Change Order #7 Dicker Road

Project: Dicker Road
Project #: STP 1902 (383) MM
Contract: C-19-017-11-05
CSJ: 0921-02-312
Limits: Spur 115 (23rd Street) to FM 2061 (Jackson Road)

Change Order #7 has been approved to make the following contract changes:

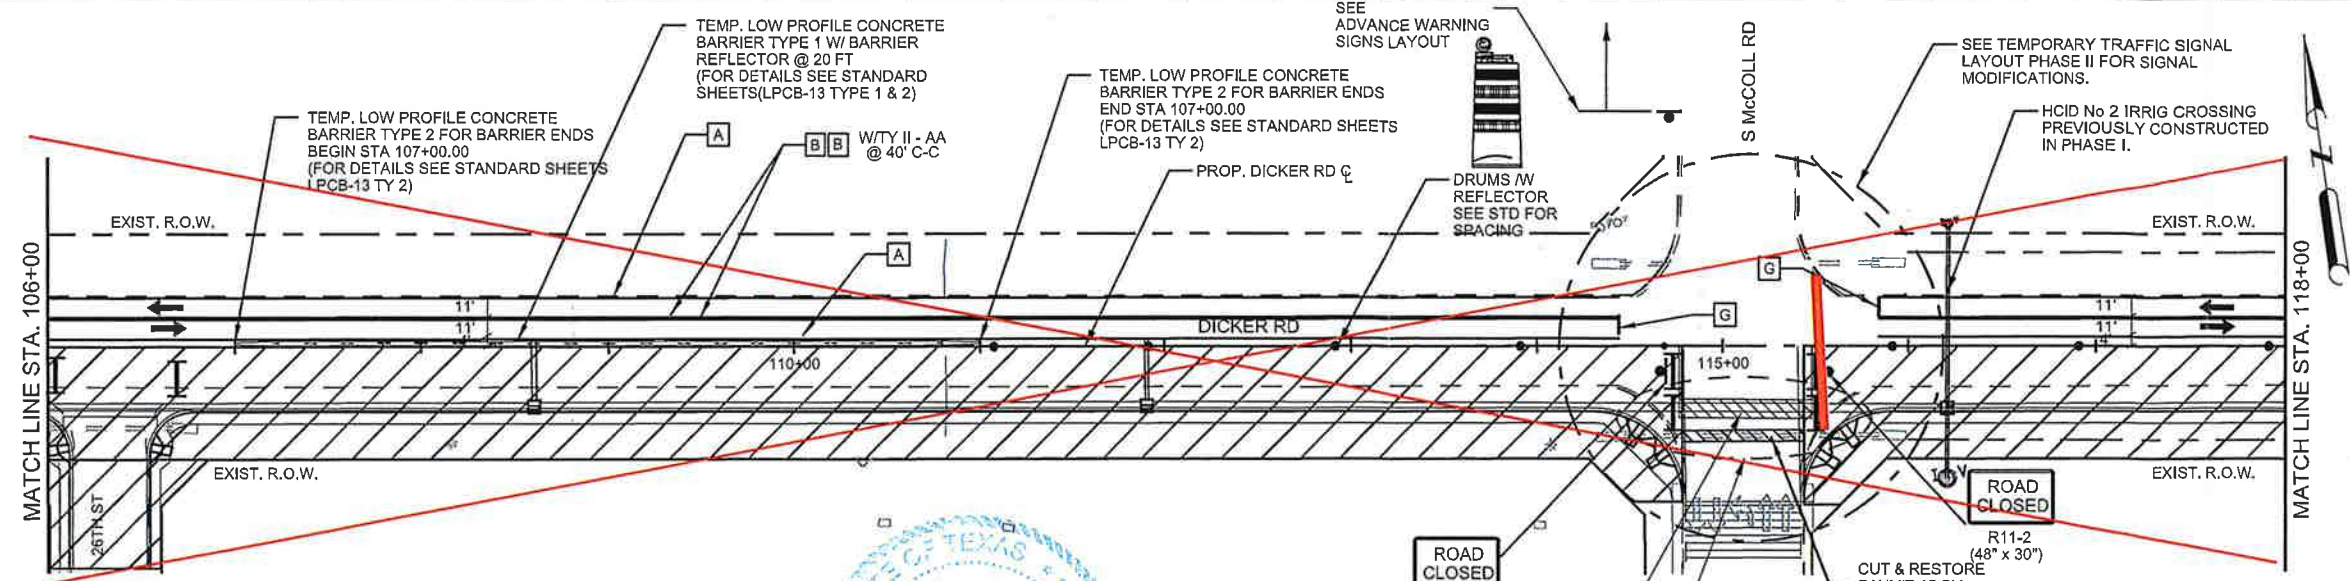
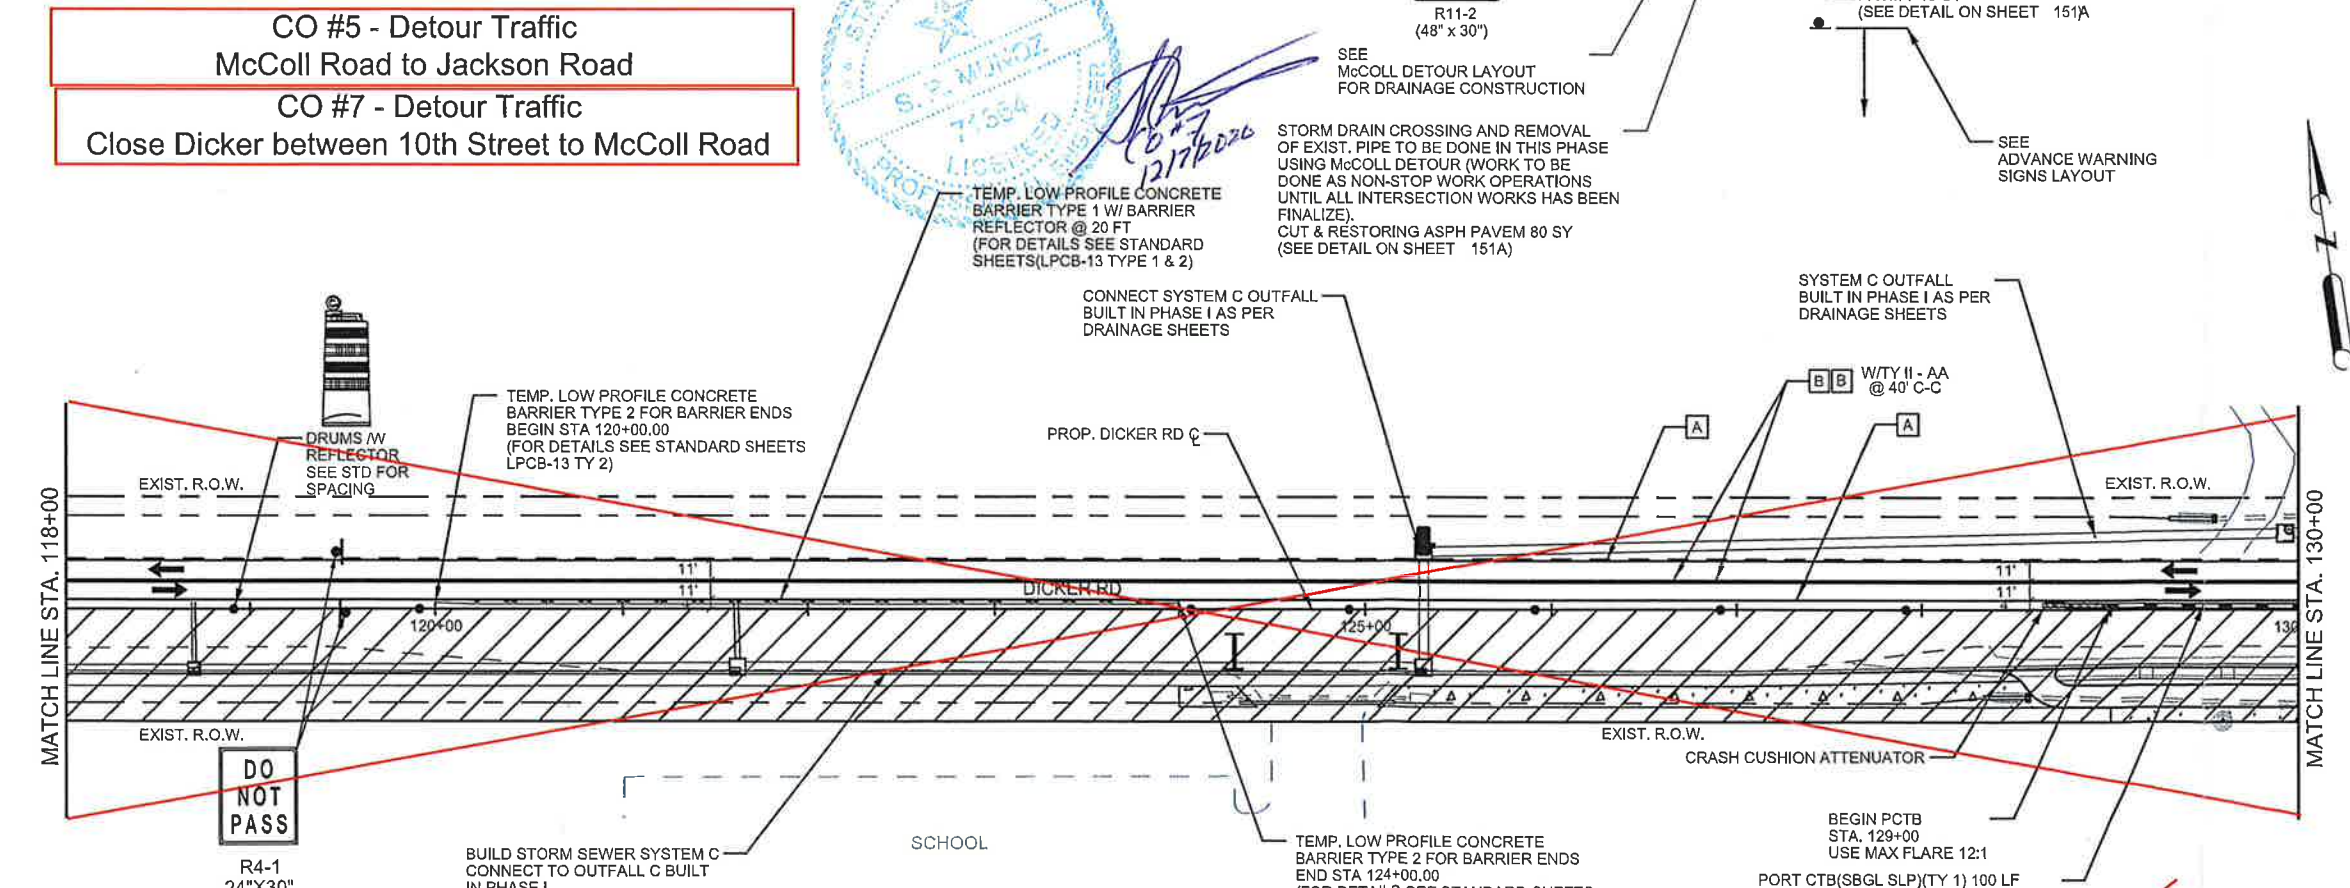
CO #7 - Detour Traffic
Close Dicker between 10th Street to McColl Road

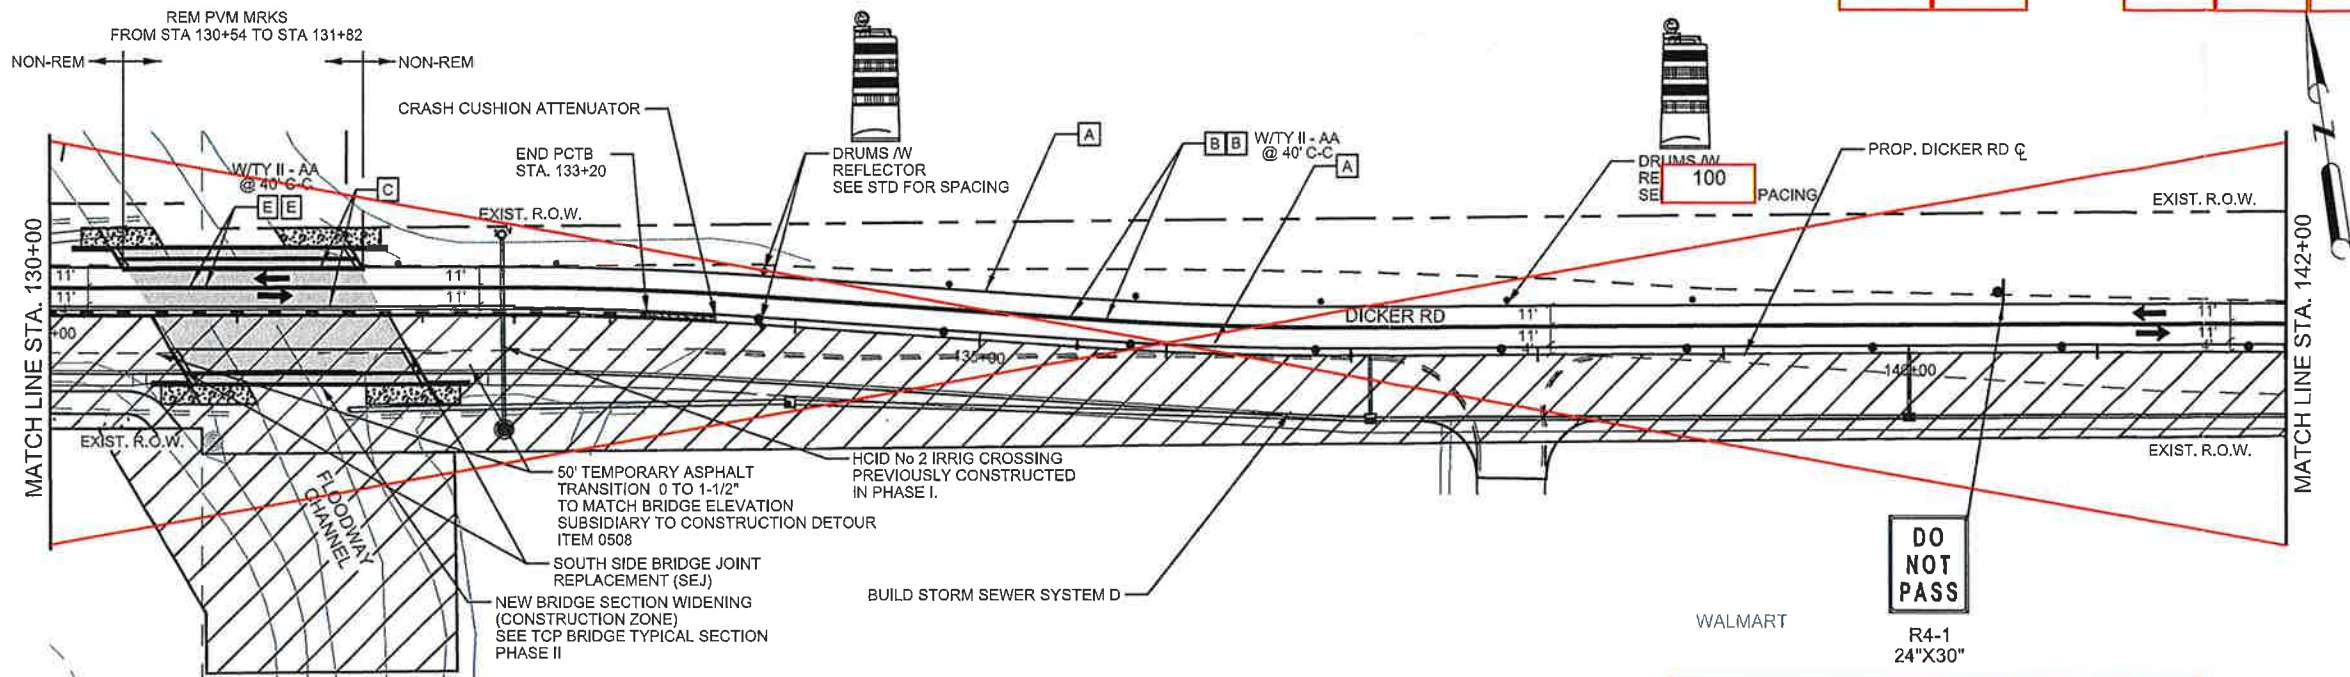
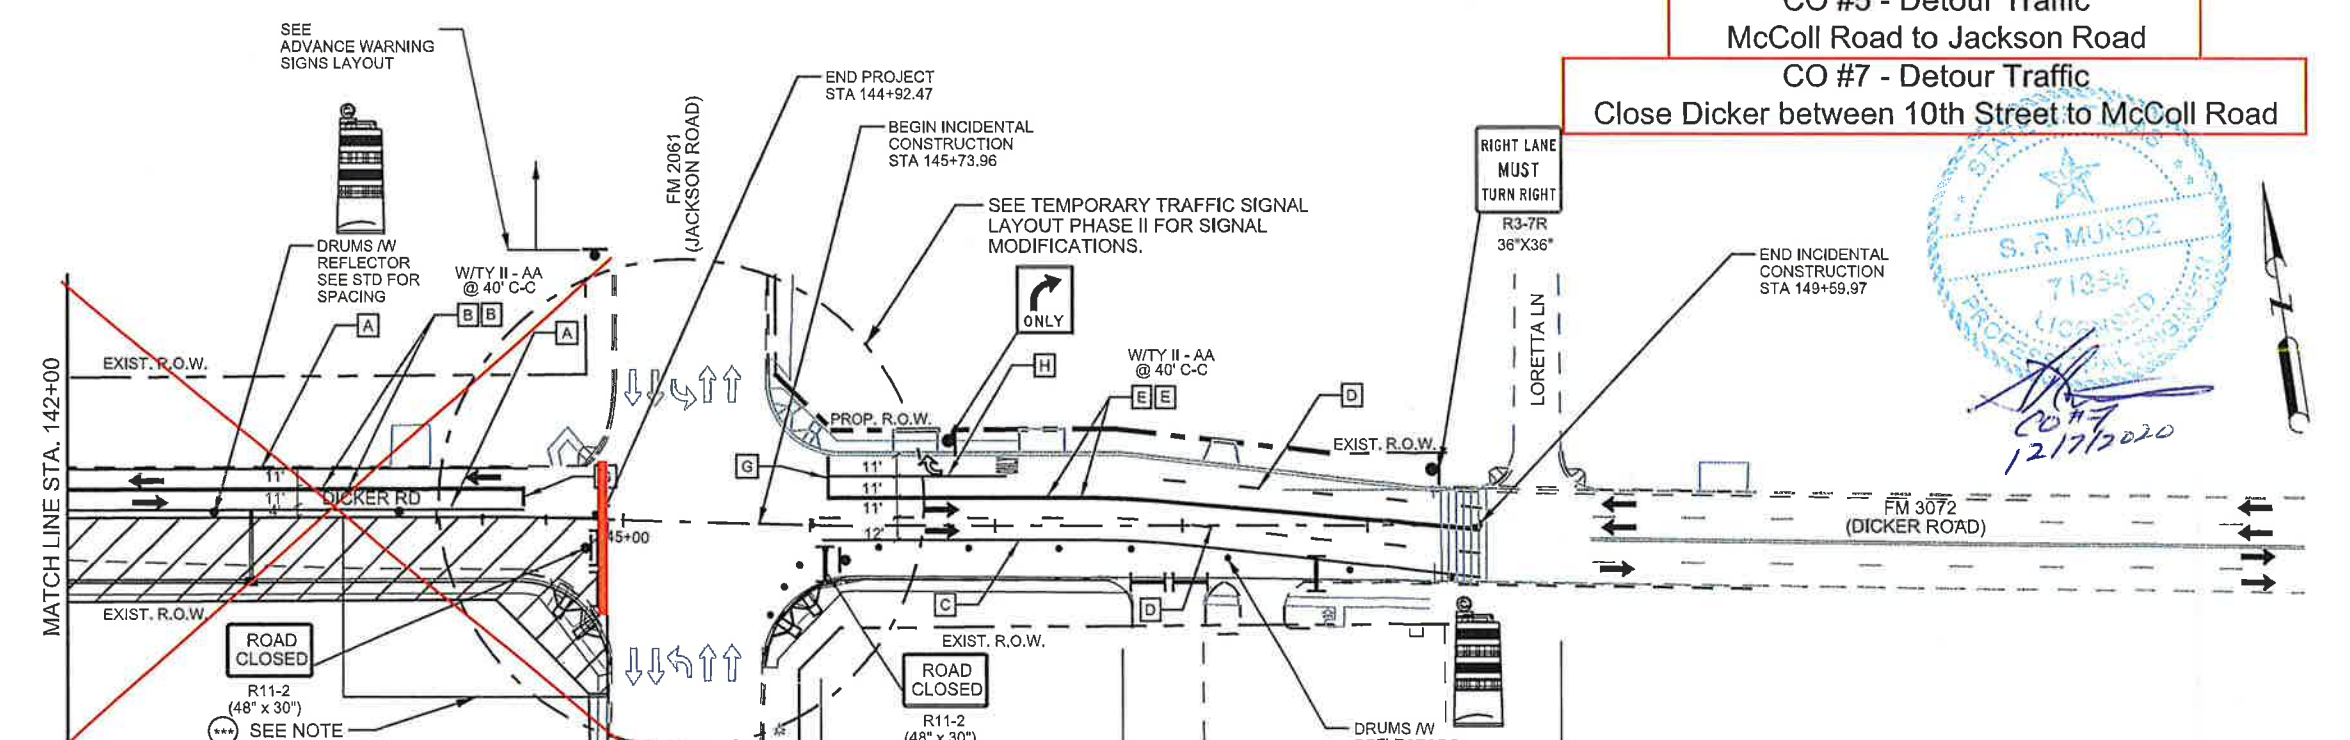
CO #5 - Detour Traffic
McColl Road to Jackson Road
CO #7 - Detour Traffic
Close Dicker between 10th Street to McColl Road

FED. RD. DIV. NO.	CONT.	SECT.	JOB.	HIGHWAY	
06	0921	02	312	DICKER ROAD	
STATE	DIST.	COUNTY	PCT.	CITY	SHEET NO.
TEXAS	PHR	HIDALGO	No 2	HIDALGO	14a

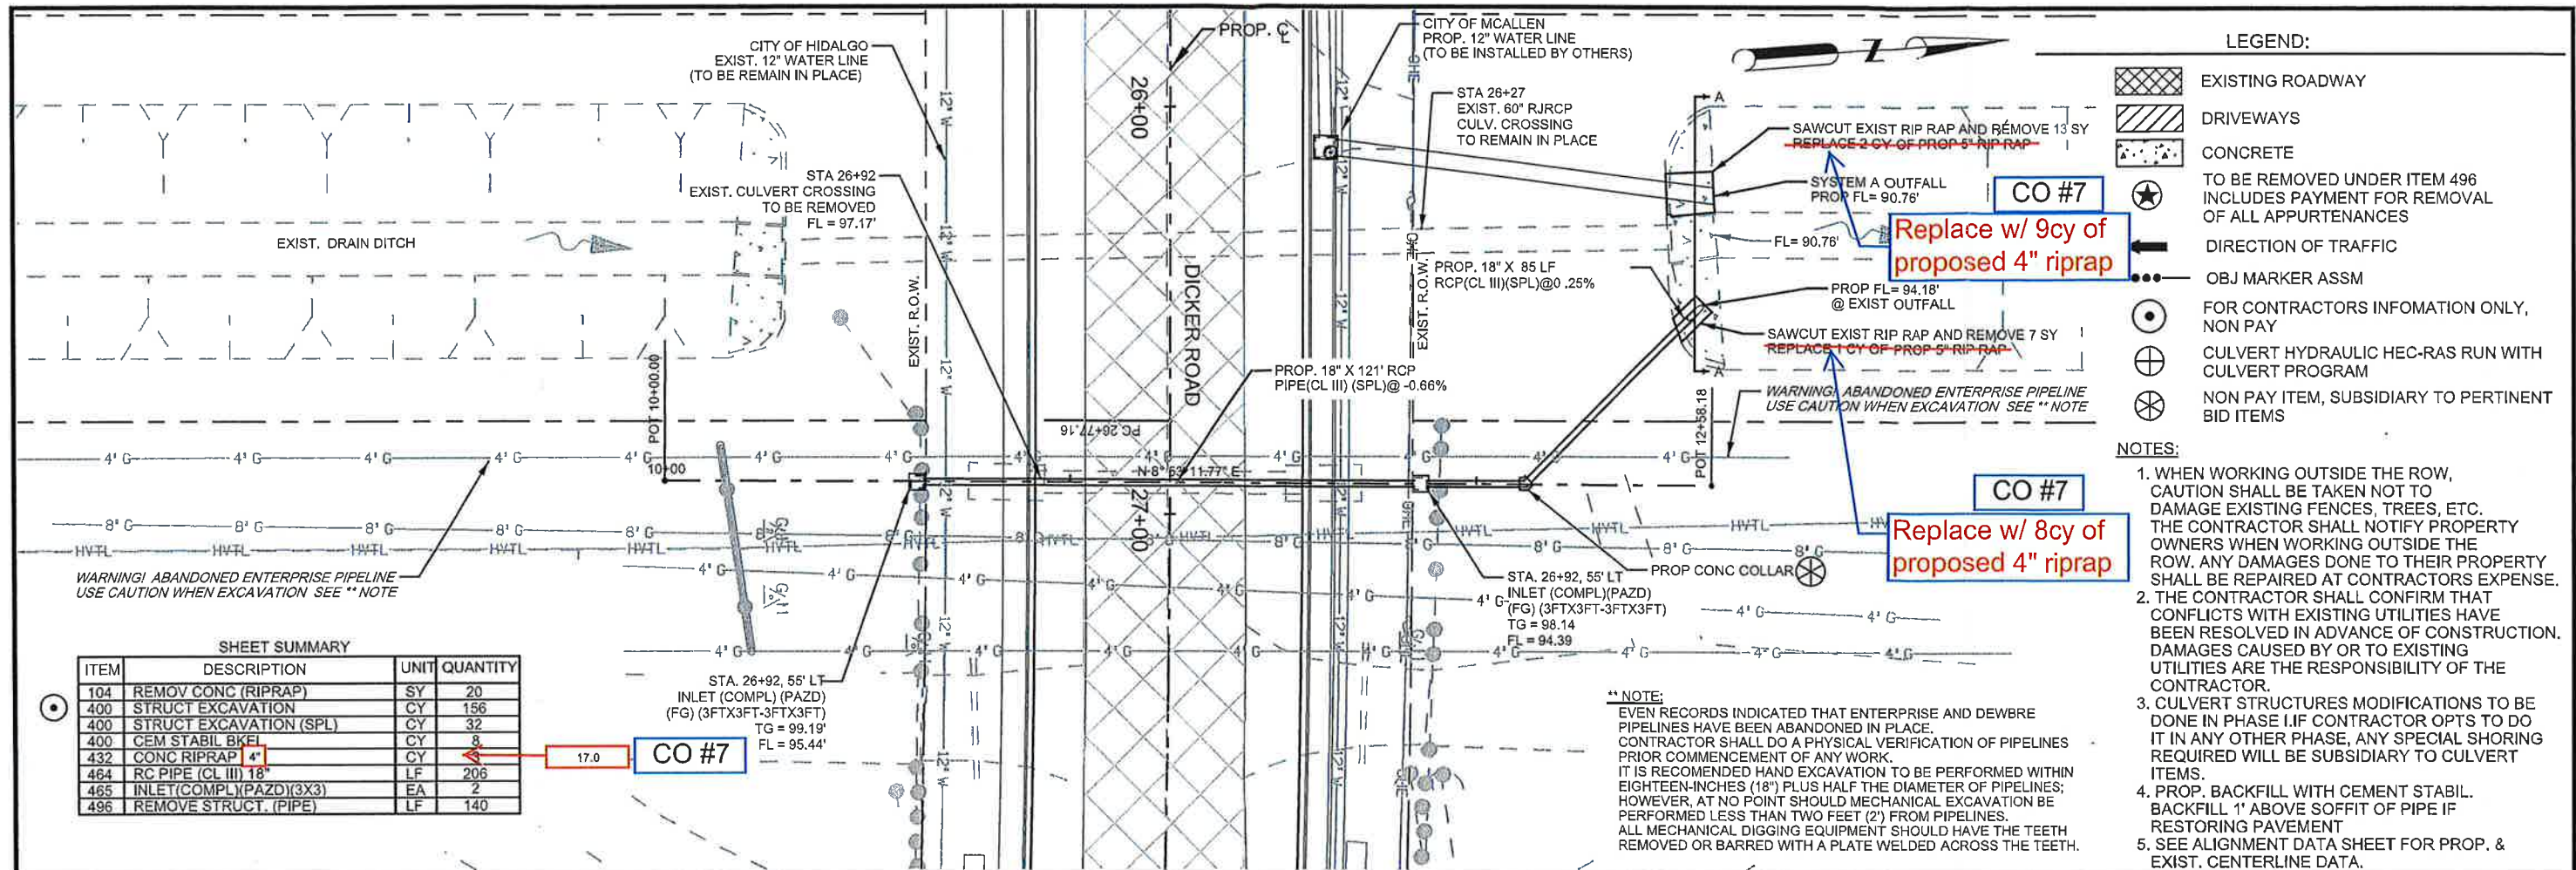
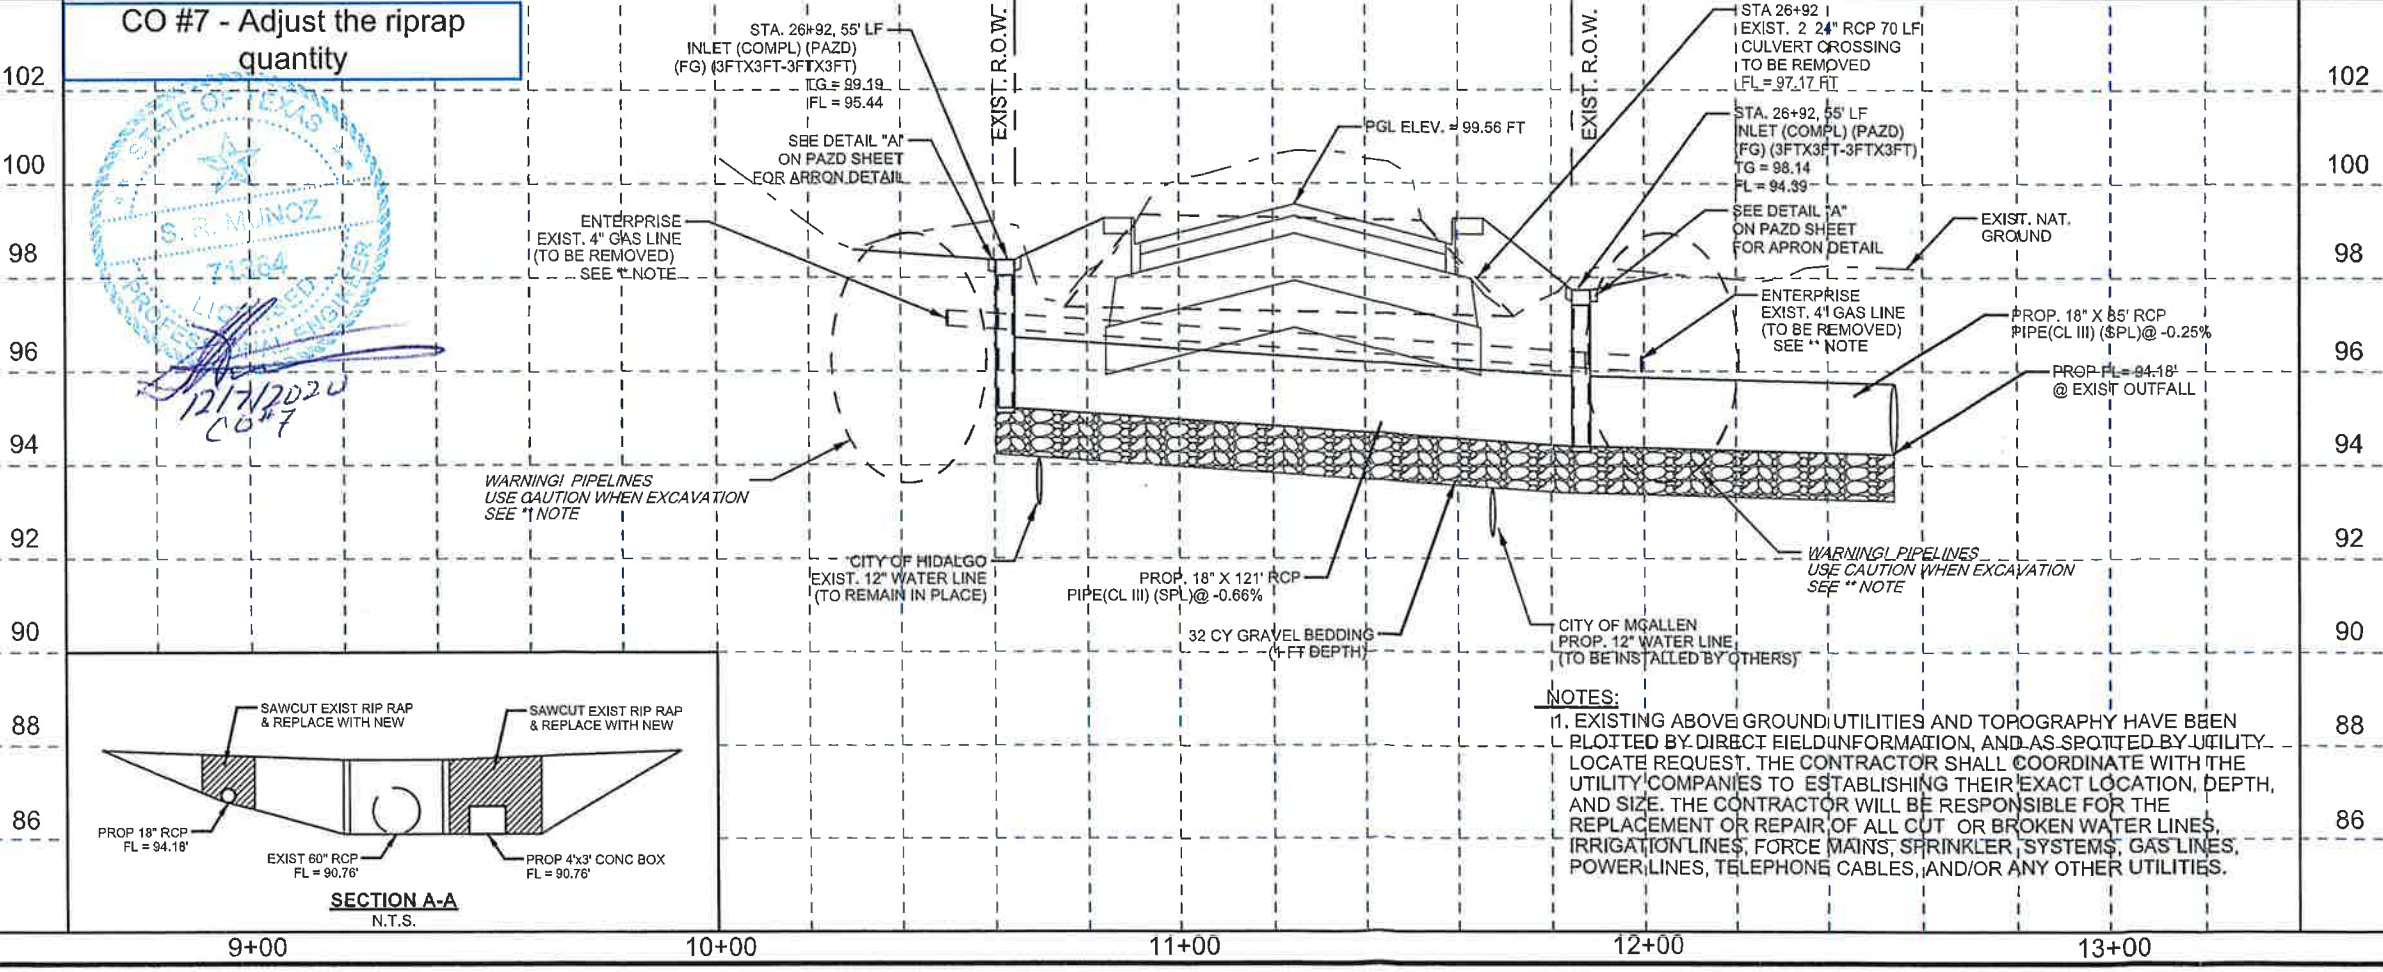
CO #7 - Adjust the riprap quantity
